Case #: ZBA 2010-68
Date: December 2, 2010
Recommendation: Conditional Approval

PLANNING BOARD RECOMMENDATION

Site: 100 Dover Street

Legal Notice: Applicant and Owner Ideal Auto Repair seeks a special permit under SZO §4.5.3 and §4.4.1 to build a 2 story 1,275 square foot addition to a nonconforming structure and expand an existing non-conforming use (motor vehicle repair §7.11.5.b and/or §7.11.6.b). CBD zone. Ward 6.

Existing conditions: North Façade

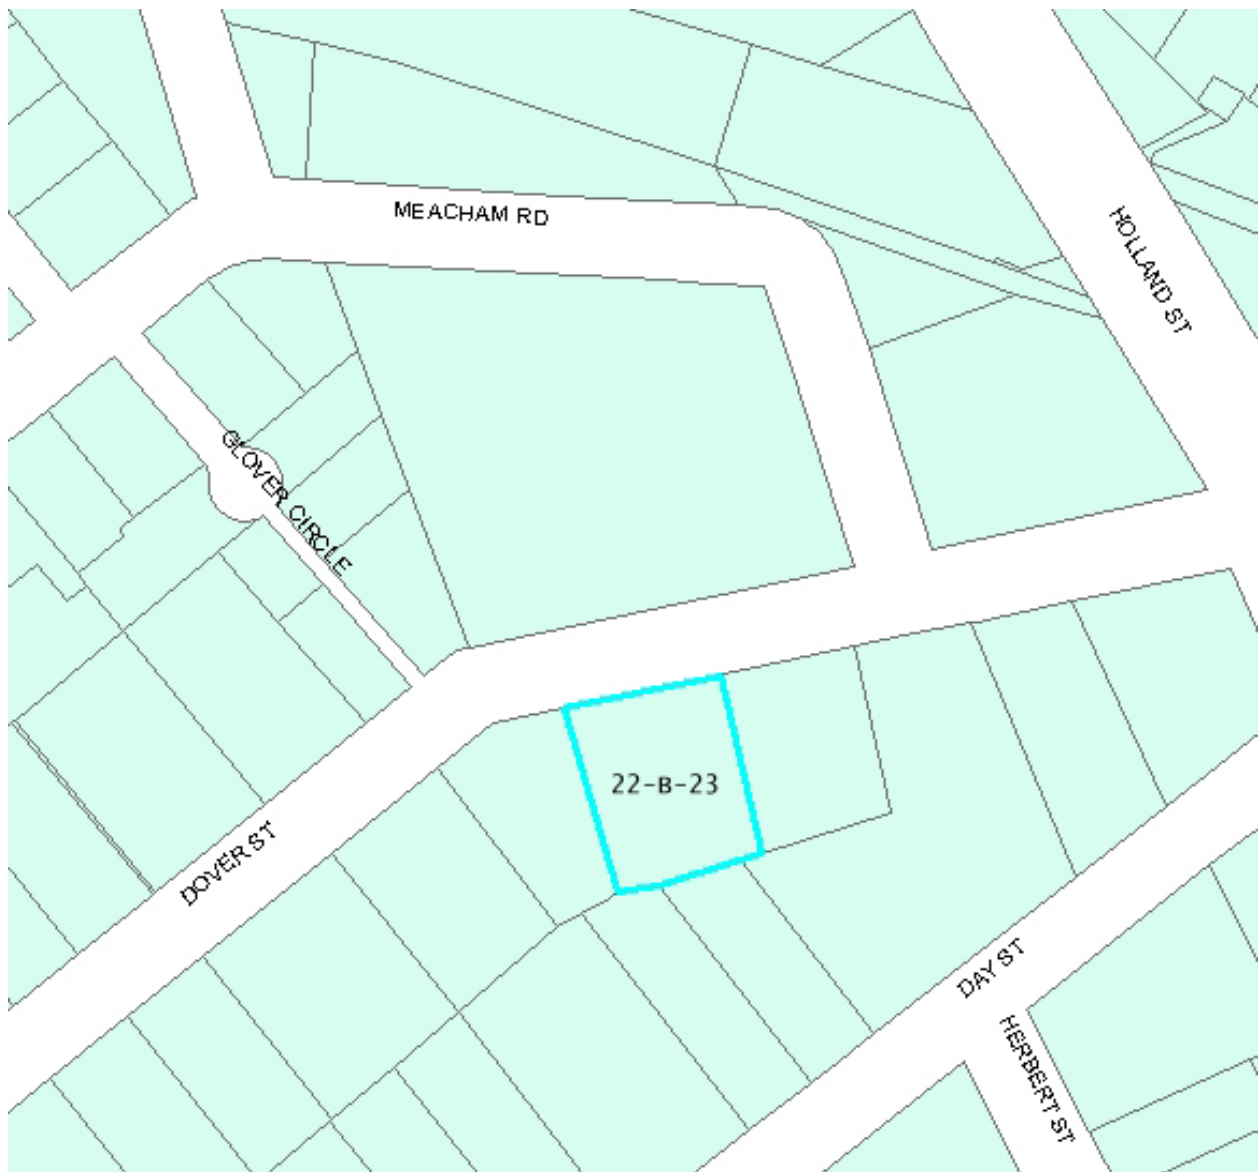
View of the existing façade & the space overlooking the new addition.
